RE: Turkey Point Unit 3 and Unit 4  
Docket Nos. 50-250 and 50-251  
Fourth 10-Year Inservice Inspection Interval  
Response to Request for Additional Information for Relief Request No. 15

**FPL Letter L-2015-172**

**Relief Request No. 15**

**Request for Additional Information (RAI)**

### 3-WR-18 and 4-WR-18

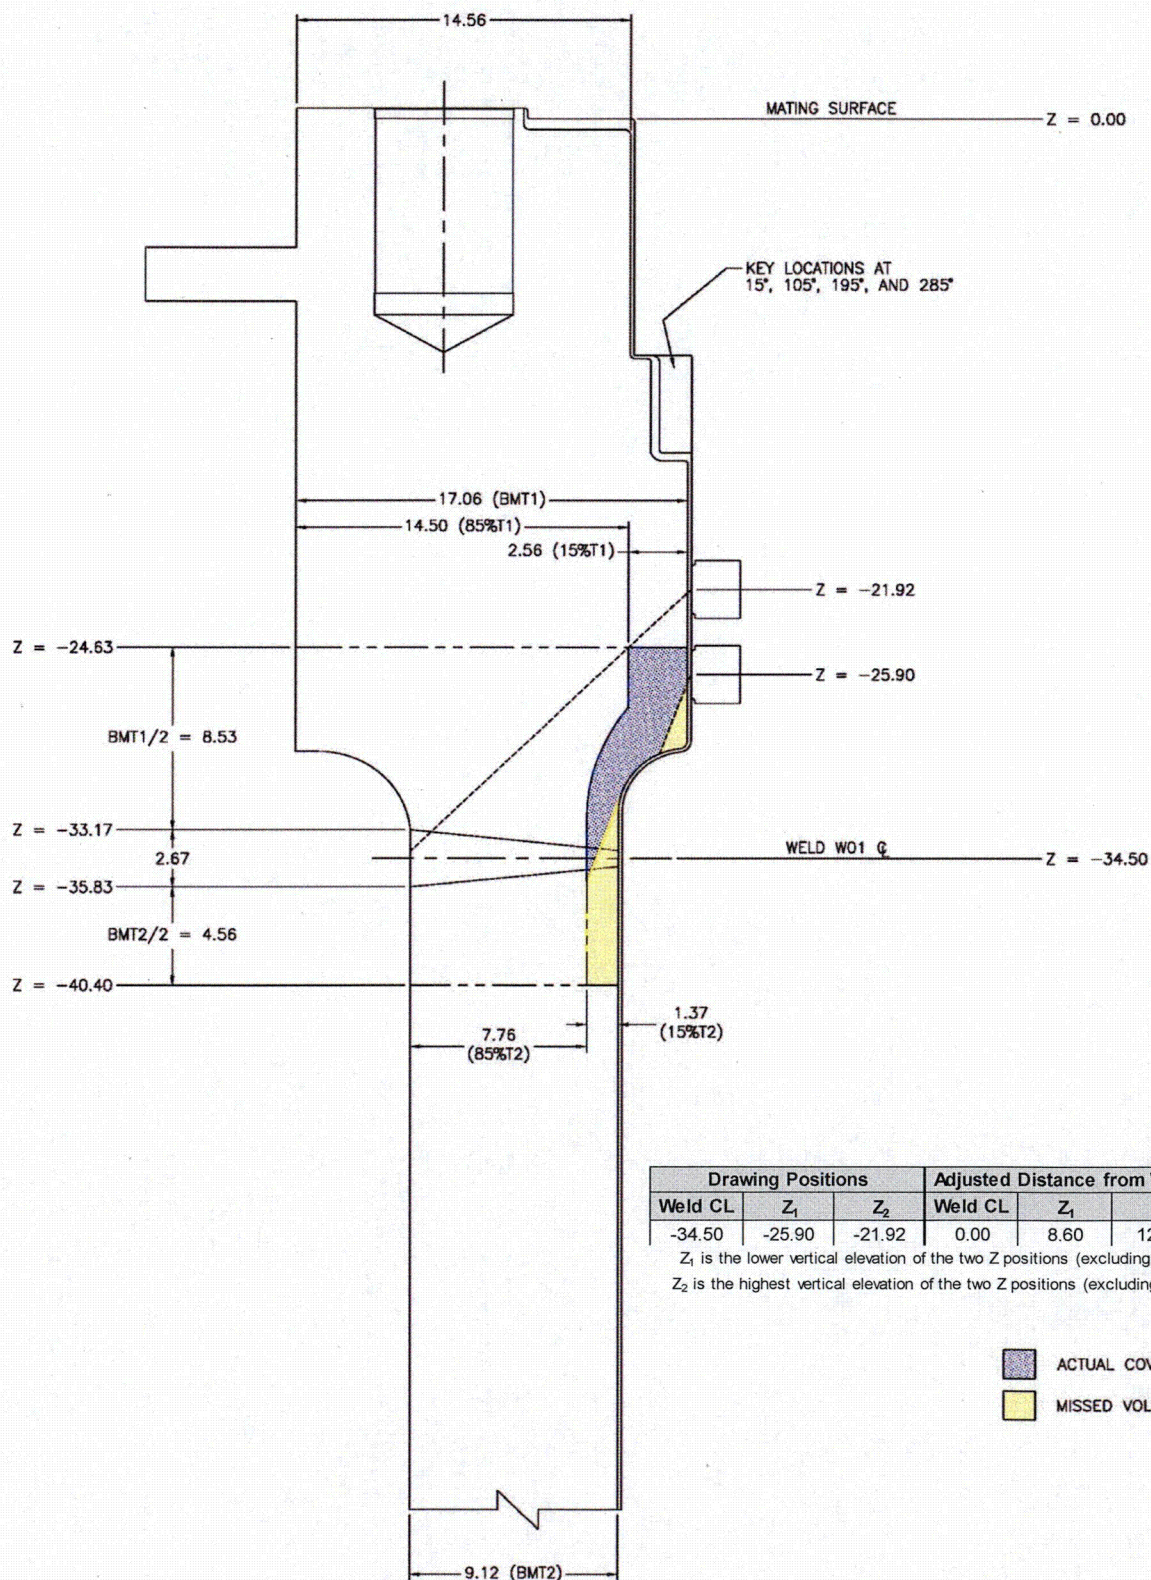
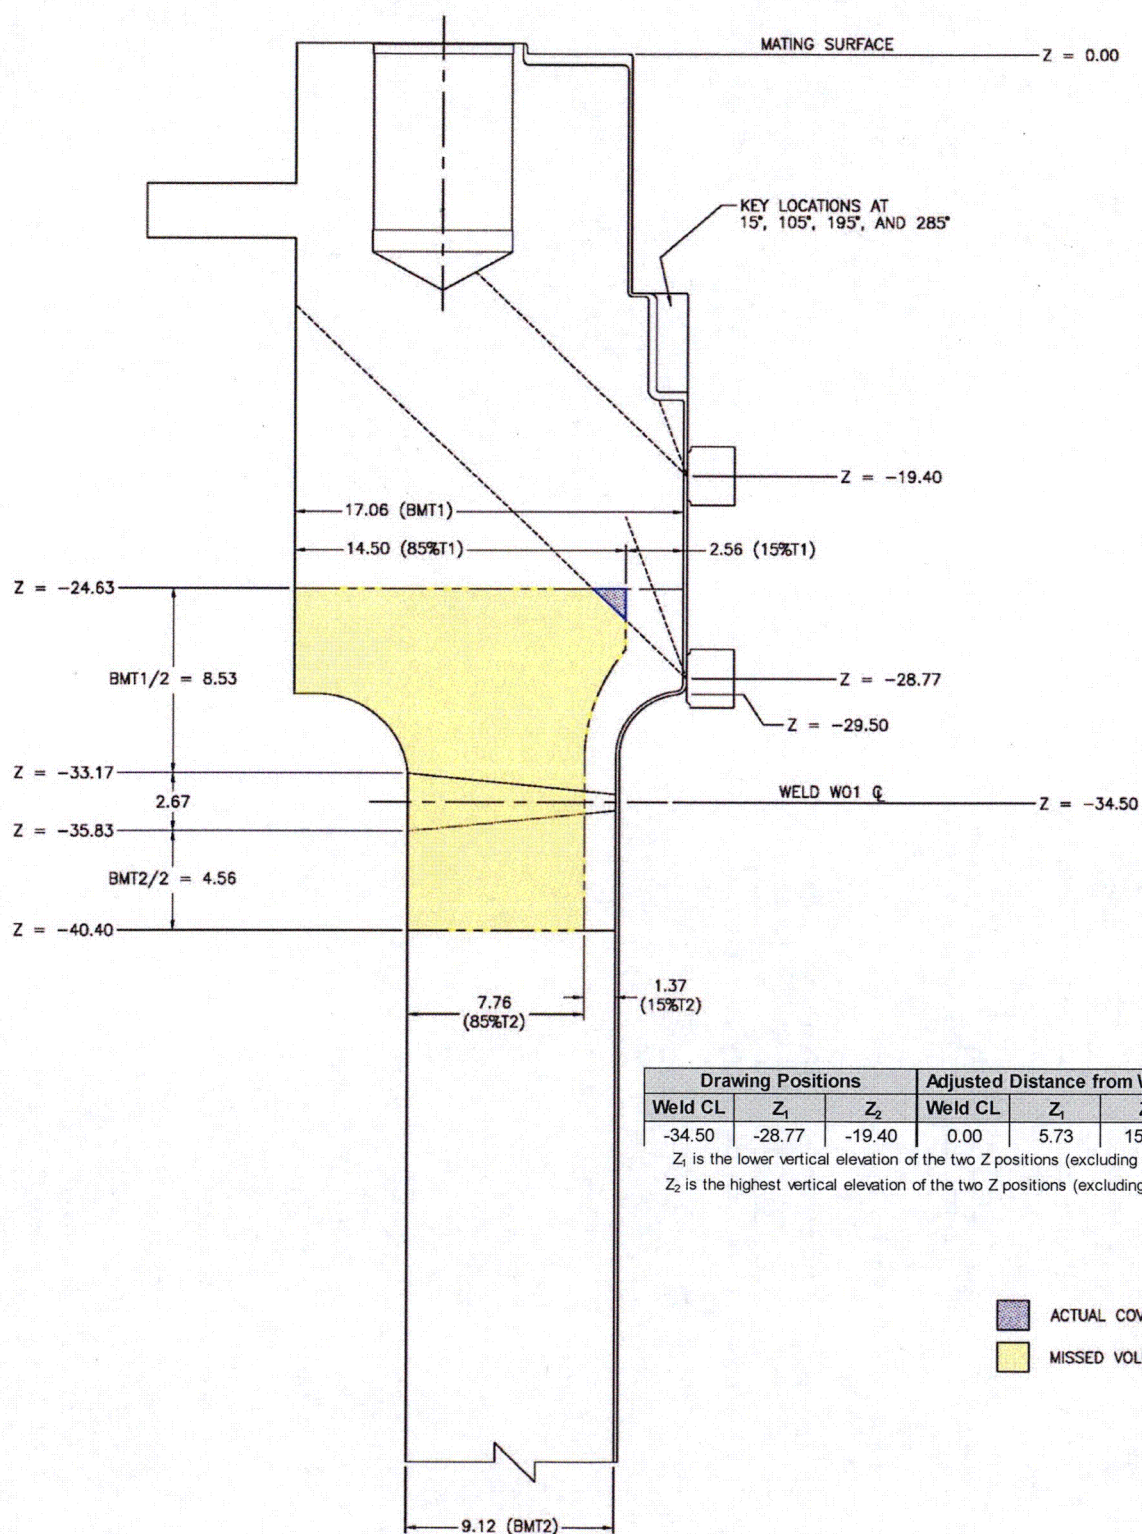
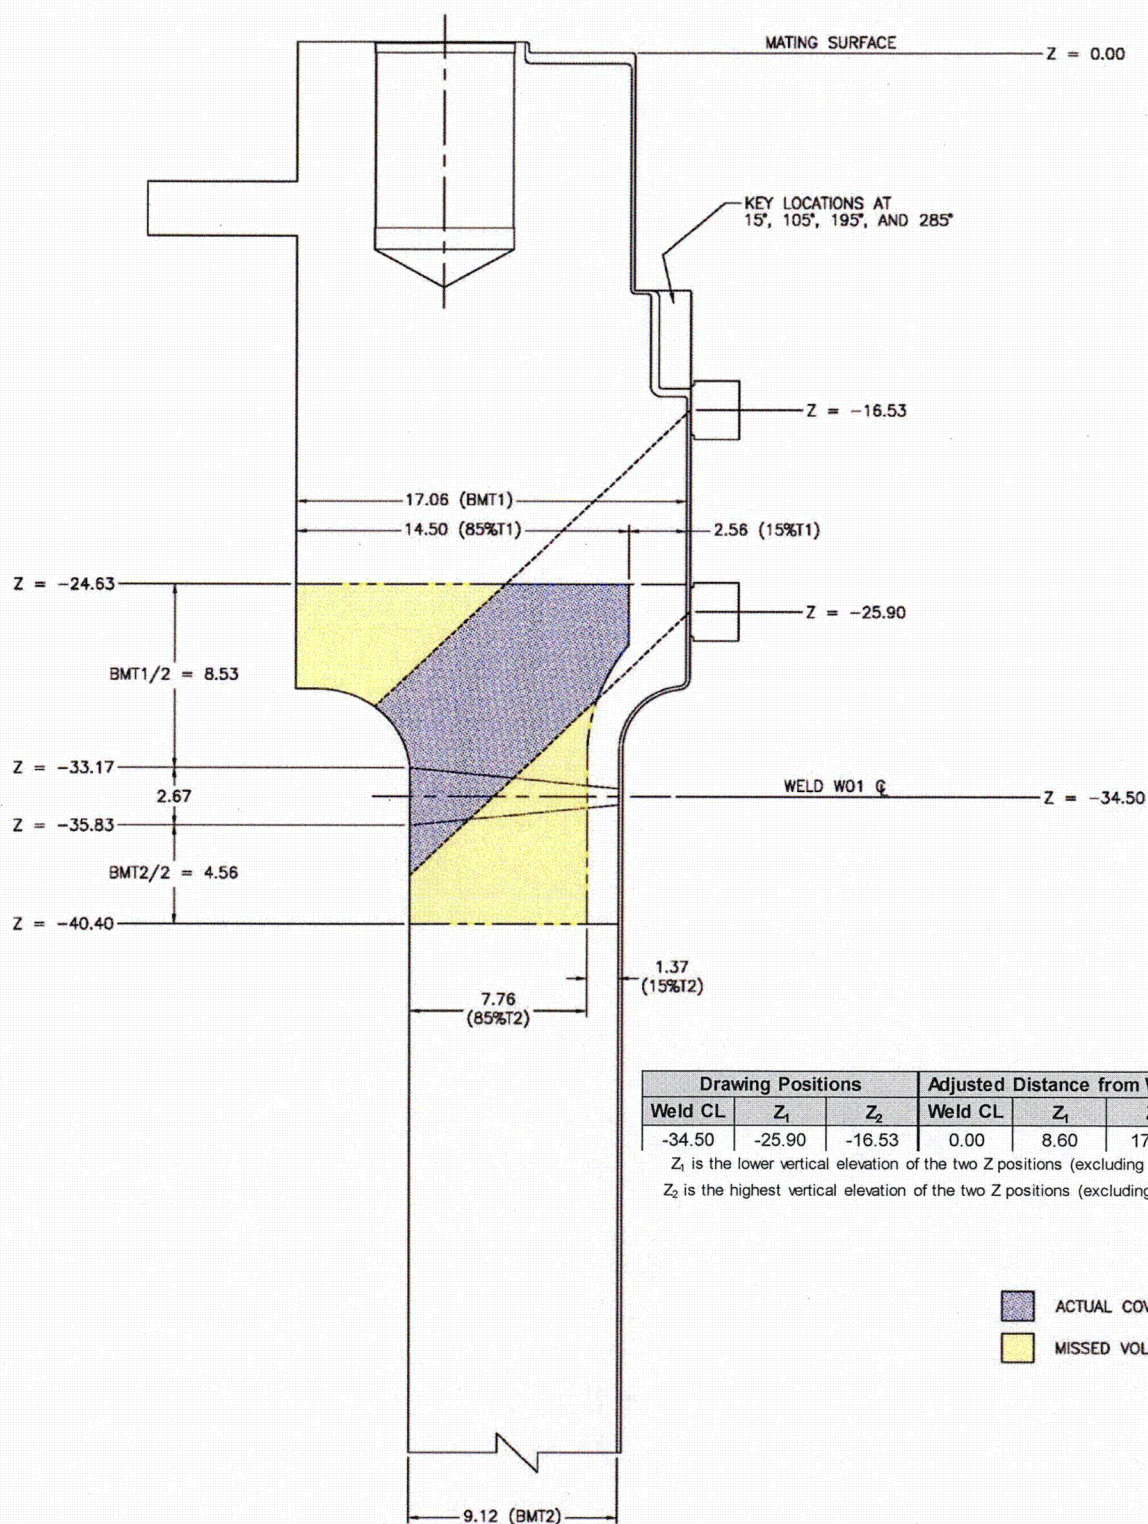
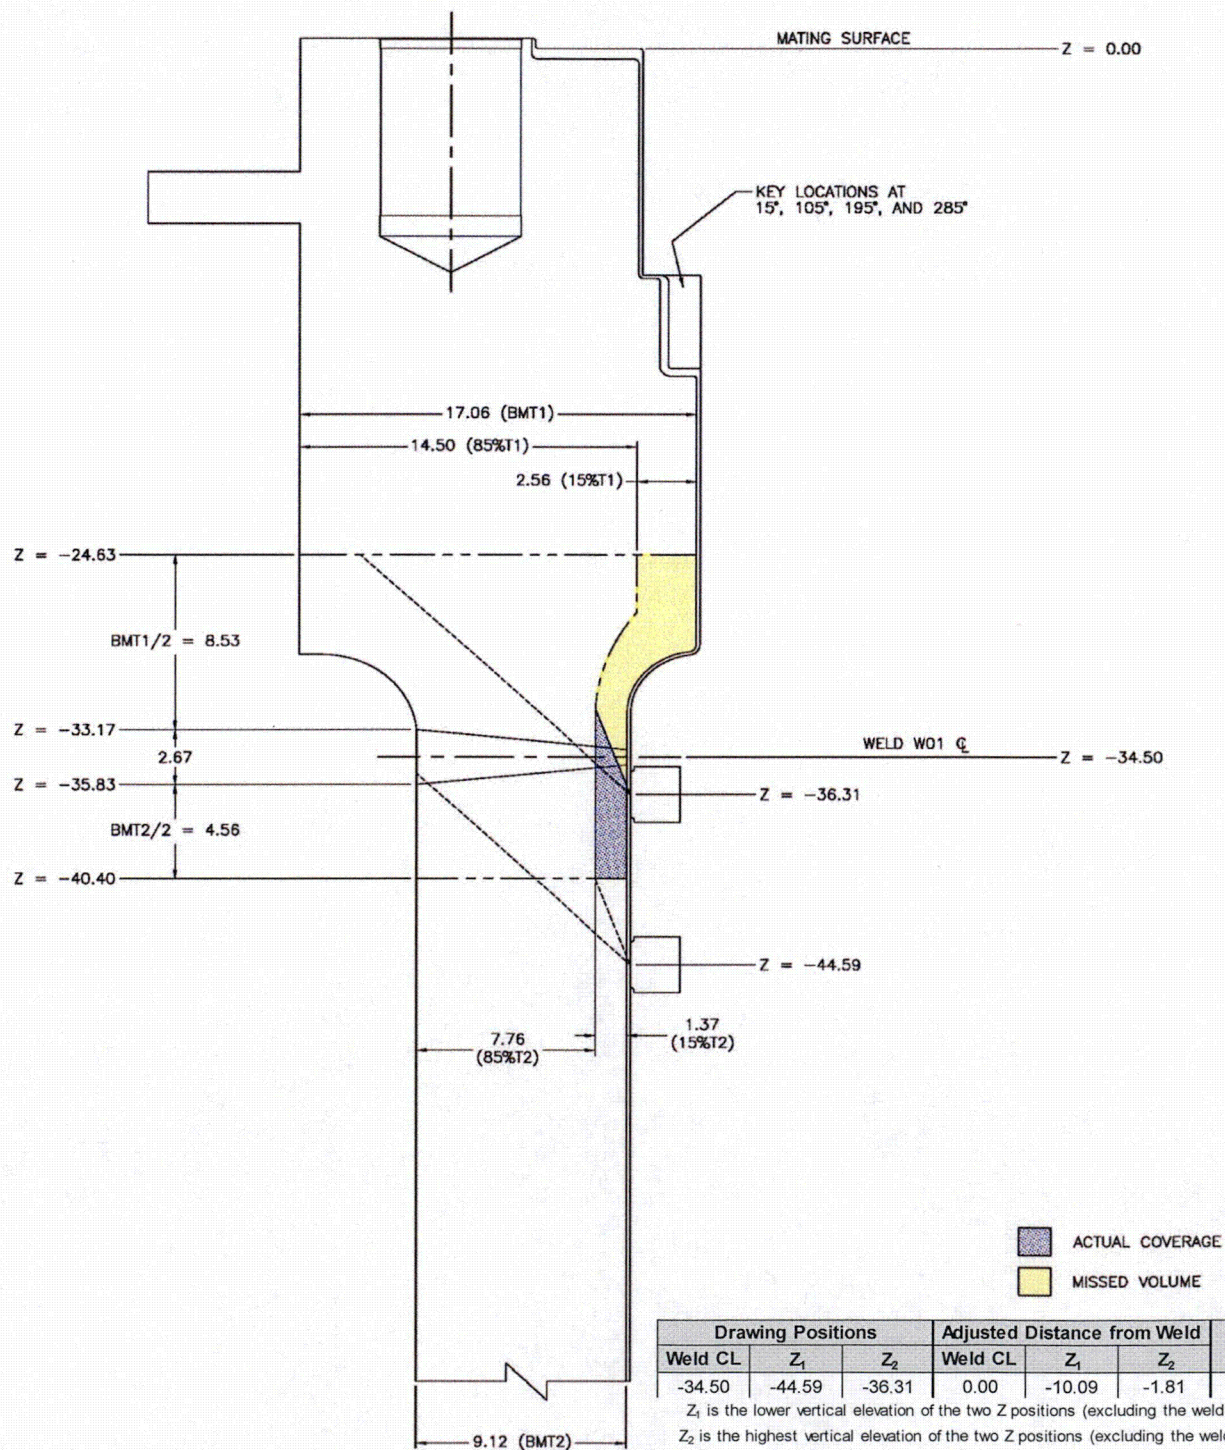
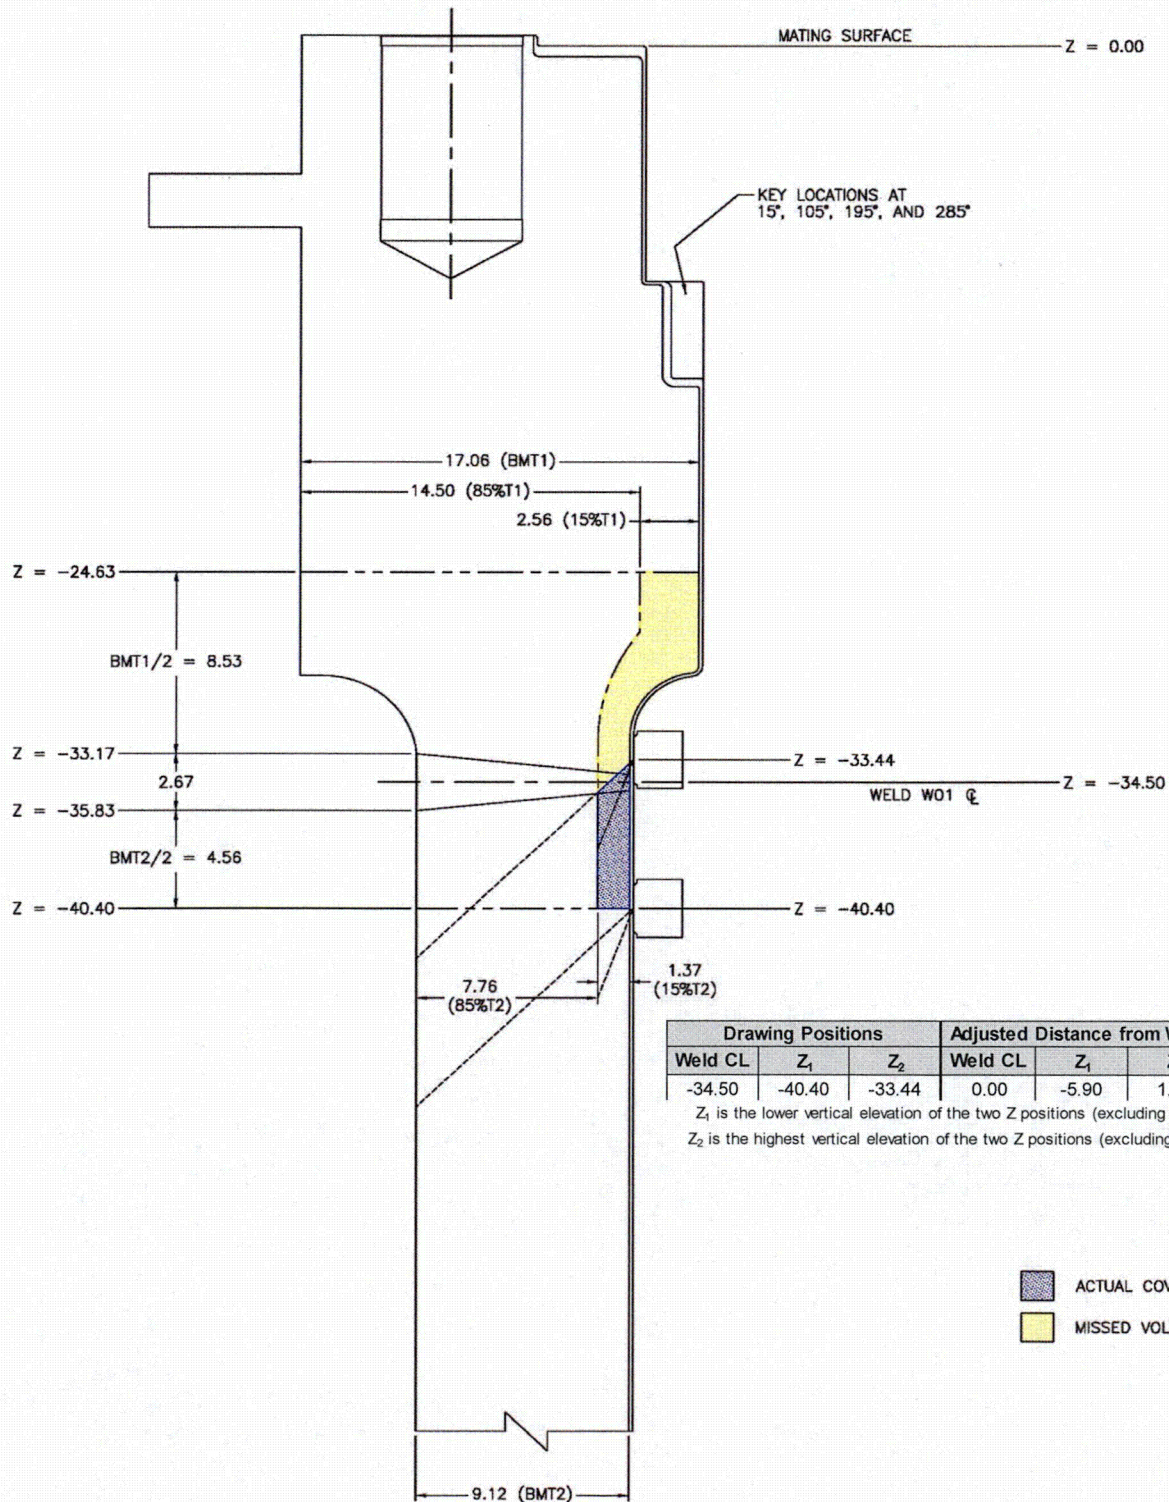
With respect to Figure 5 for Category B-A, Item B1.30, Upper Shell to Flange Welds (Weld 3-WR-18 for Unit 3 and 4-WR-18 for Unit 4), provide the following information in a diagram showing: (1) the ASME Code, Section XI required examination volume, (2) the scan angles and axial distances of the search units from the welds used for the examination, and (3) the actual scanned volumes for both the axial and circumferential scan directions. Please refer to the industry/NRC information exchange public meeting held on January 13 -15, 2015 (ADAMS Accession Number ML15013A266), for a discussion of the NRC staff's expectations for the content of an inspection diagram (see Slide 12 for an example).

- (1) The ASME Code, Section XI required examination volume is illustrated on pages 12 through 23 of this enclosure. The examination volume includes the weld and 1/2 "T" of the base material on each side of the weld for the complete through wall thickness.
- (2) The scan angles and axial distances of the search units from the welds used for the examination are located on the inspection diagrams on pages 12 through 23 of this enclosure. The search unit shown in the illustrations does not reflect the actual size of the UT head configuration. Refer to Figure 1 of the original relief request.
- (3) The actual scanned volumes for both axial and circumferential scan directions are located on page 11 of this enclosure.
